Item Name: Crosstube Assembly, Mid Aft

DRAWING NO. D206-667-247	TITLE CROSSTUBE ASS'Y (206L-MID AFT)	REV. A	DART AEROSPACE LTD ENGINEERING ORDER		D.E.O. NO. D206-667-247-A-1	SHEET NO. SHEET 1 OF 1	SCALE NTS
DRAWN <i>qp</i>	CHECKED <i>ASS</i>	MFG. APPR. <i>KD</i>	APPROVED <i>JMP</i>		DE APPR. <i>#</i>		
DATE 11.07.15	DATE 11.07.20	DATE 11.07.21	DATE 11/07/21		DATE 11.07.21

PURPOSE:

REPLACE MAGNOBOND WITH PROSEAL

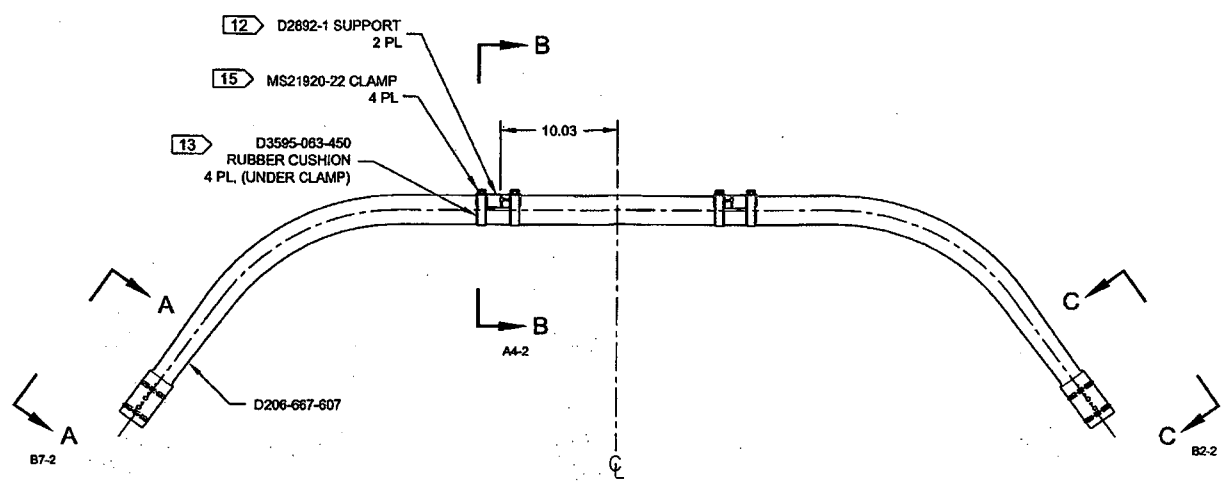
9	A/R	MAGNOBOND 6398	ROCKWELL SPECIFICATION RBO-120-023 ADHESIVE (TEXTRON/BELL SPEC. 299-947-100, TYPE II, CLASS 2 ADHESIVE)
---	-----	----------------	---

NOTE 12 & 15, SHEET 1 IS AMENDED AS FOLLOWS:

- 12) INSTALL D2892-1 SUPPORT USING 0.03" TO 0.06" THICK LAYER OF MAGNOBOND 6398 PER QSI 015. LET CURE FOR 12 HOURS AFTER INSTALLATION AND PRIOR TO PACKAGING.
- 15) TORQUE CLAMPS 80 TO 100 IN-LB. ENSURE AT LEAST 1.5 THREADS SHOWING IN SAFETY AND THAT NUT HAS NOT BOTTOMED-OUT AFTER TORQUING.

Item	Qty -247	Part Number	Description
9	A/R	PROSEAL 890 B-2	SEALANT, AMS-S-8802 CLASS B-2

- 12) TO INSTALL D2892-1 SUPPORT: ABRASE MATING SURFACE OF SUPPORT AND CROSSTUBE WITH 180-GRIT SANDPAPER AND REMOVE RESIDUE WITH MEK (OR EQUIVALENT). APPLY A 0.04" TO 0.07" THICK LAYER OF PROSEAL 890 CLASS B-2 (OR AMS-S-8802 CLASS B-2) SEALANT TO MATING SURFACE OF SUPPORT.
- 15) TORQUE CLAMPS 80 TO 100 IN-LB. ENSURE AT LEAST 1.5 THREADS SHOWING IN SAFETY AND THAT NUT HAS NOT BOTTOMED-OUT AFTER TORQUING. **PRIOR TO PACKAGING, RE-CHECK TORQUE ON CLAMPS AFTER PROSEAL 890 SEALANT HAS CURED FOR 72 HOURS.**
